Network Camera Firmware
Version: V5.4.5
Release Note(External)
(2017-02-28)

Hikvision Firmware V5.4.5 Features

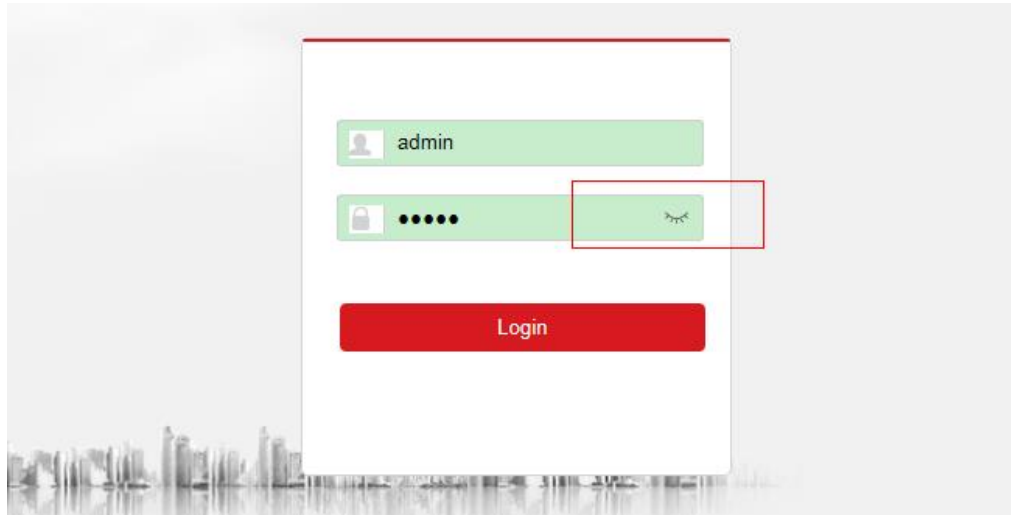
● **Admin account user is able to enable/disable Hik-Connect service. Admin account user is able to view verification code for Hik-Connect service on web browser or iVMS-4200.**

● **Time zones of particular areas are updated: Istanbul is changed to GMT+3:00 and Novosibirsk is changed to GMT+7:00.**

● **In DST configuration of French web page, the typo of Tuesday and Thursday is corrected.**

● **Intrusion detection and line crossing detection alarm types are available on Hik-Connect service.**

Note: Intrusion detection and line crossing detection rules should be configured on web browser, iVMS client or NVR after enabling Alarm Notification on Hik-Connect APP.

● **It supports to check the password when login in via Web.**
